UNITED STATES PATENT AND TRADEMARK OFFICE

Office Action Summary	Application No. 10/595,366	Applicant(s) AN, BYUNG-MOO	
	Examiner Jay R. Ripley	Art Unit 3679

DETAILED ACTION

(Bridges Figure 1)

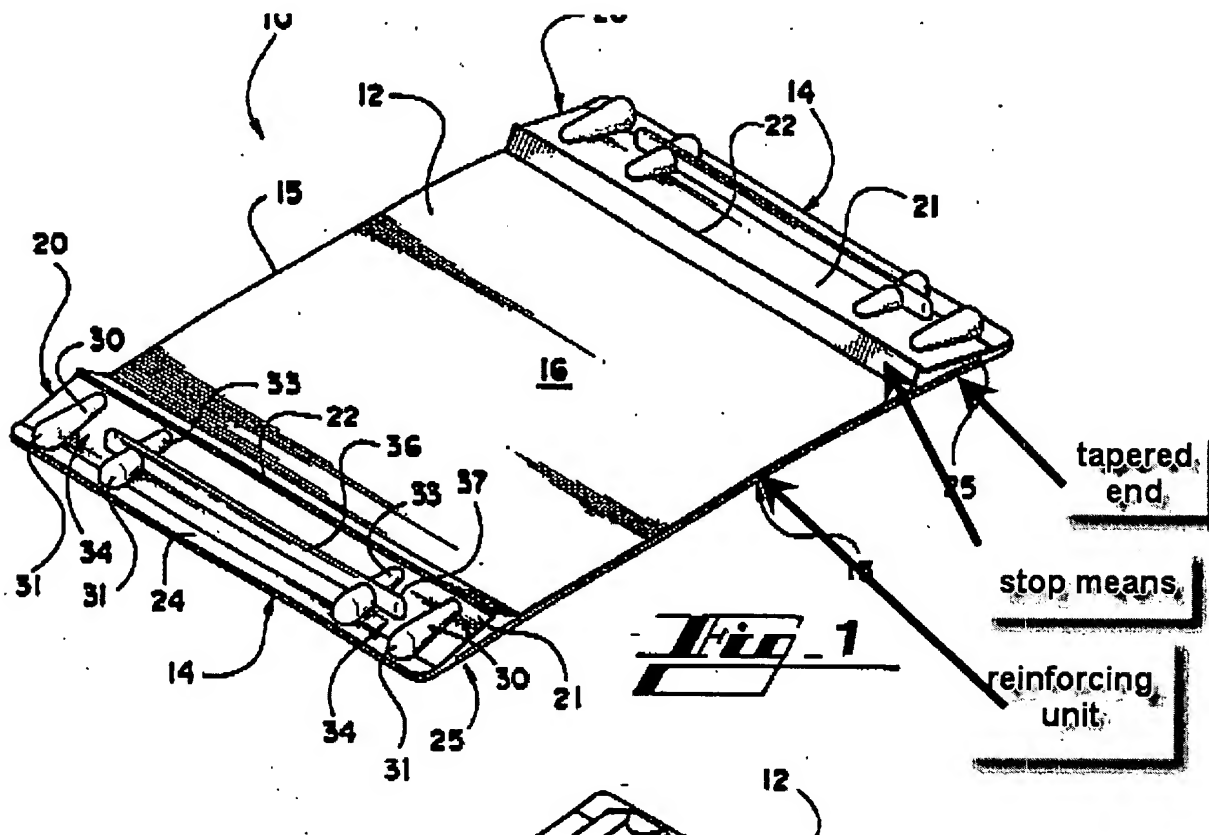
7. In regard to claim 1, Bridges discloses in Figures 1, 4, 6, below, a pipe joint, comprising:
a body part provided by rolling a planar material to form a cylindrical structure;

a coupling part having a bent surface at each of both ends of the body part, with a plurality of locking holes provided on the bent surface of the coupling part;

locking means tightened into the locking holes to couple the both ends of the body part to each other; and

a reinforcing unit comprising a separate curved plate, the reinforcing unit being reduced in thickness at both ends thereof to be in close contact with an inner surface of the body part.

9. In regard to claim 2, Bridges further discloses in Figure 1, above, that the reinforcing unit further comprises a stop means having a stepped shape.
10. In regard to claim 3, Bridges further discloses in Figure 3, below, that the body part is stepped around a predetermined portion thereof so that upper and lower parts of the body part differ in inner and outer diameters from each other.

(Bridges Figure 4)

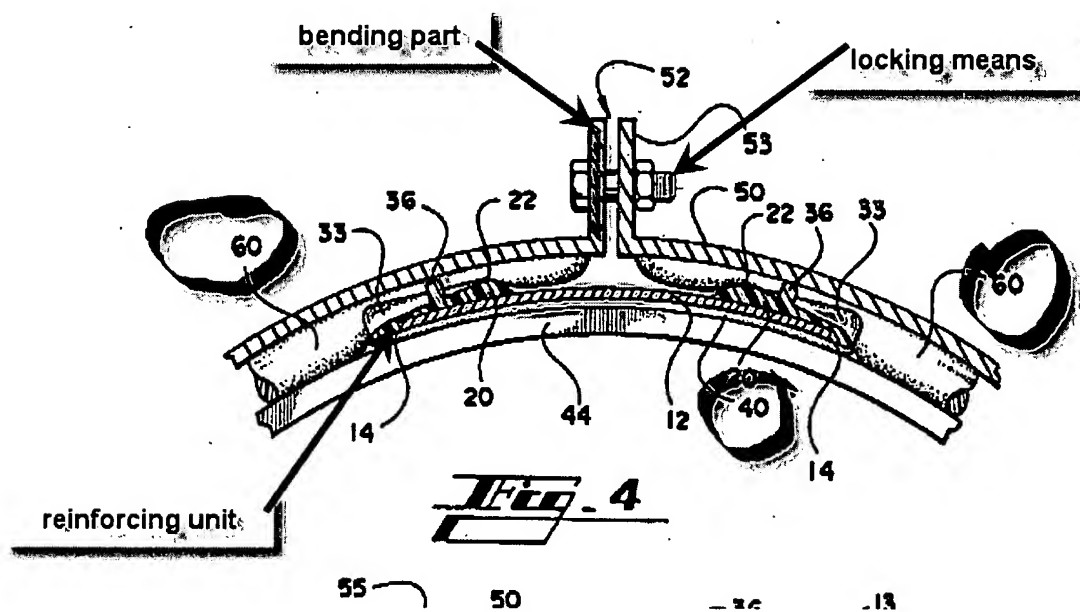
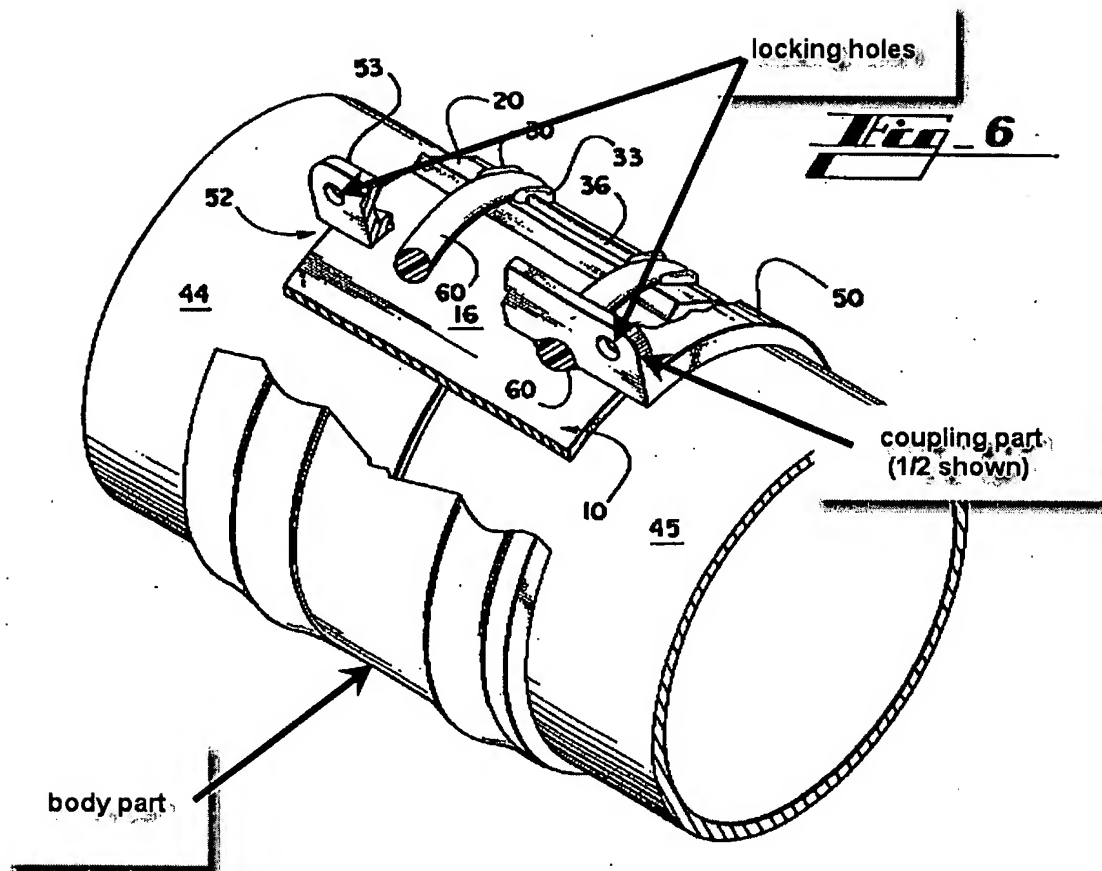
11. In regard to claims 4/1, 4/2, and 4/3, Bridges further discloses in Figure 4, above, a sealing unit provided inside each of the body part (arcuate gasket part 60) and the reinforcing unit (circumferential sealing pad part 40).

13. In regard to claims 6/1, 6/2, and 6/3, Bridges further discloses in Figure 4, above, that each of the coupling parts comprises a bending part.
